AMENDMENT NO. 3 MARCH 1989
TO
IS : 3347 (Part 2/Sec 2) - 1979 DIMENSIONS FOR
PORCELAIN TRANSFORMER BUSHINGS FOR
USE IN NORMAL AND LIGHTLY POLLUTED
ATMOSPHERES

PART 2 3.6 kV BUSHINGS

Section 2 Metal Parts

FIG. 12 GASKET (R AND X TYPE)

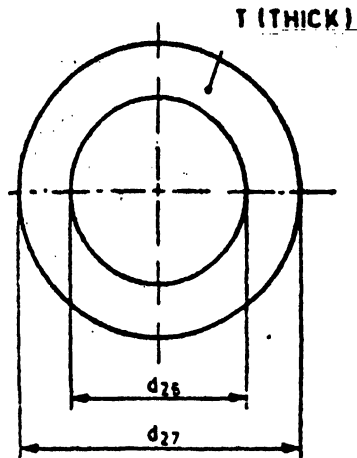
(Page 15, Fig. 12) — Substitute the figure given on page 2 for the existing figure.

TYPE	RATING kV/A	BUSHING WITH ALUMINIUM STEM			BUSHING WITH COPPER STEM		
		d_{26}	d_{27}	T	d_{26}	d_{27}	T
(1)	(2)	(3)	(4)	(5)	(6)	(7)	(8)
R	3.6/250	45	70	3	28	50	3
R	3.6/630	56	90	3	40	70	3
R	3.6/1 000	70	104	3	45	70	3
R	3.6/2 000	90	125	3	70	104	3
R	3.6/3 150	—	—	—	90	125	3
X	3.6/250	40	70	3	25	50	3
X	3.6/630	45	70	3	45	70	3
X	3.6/1 000	63	90	3	56	90	3
X	3.6/2 000	80	110	3	70	104	3
X	3.6/3 150	—	—	—	90	125	3
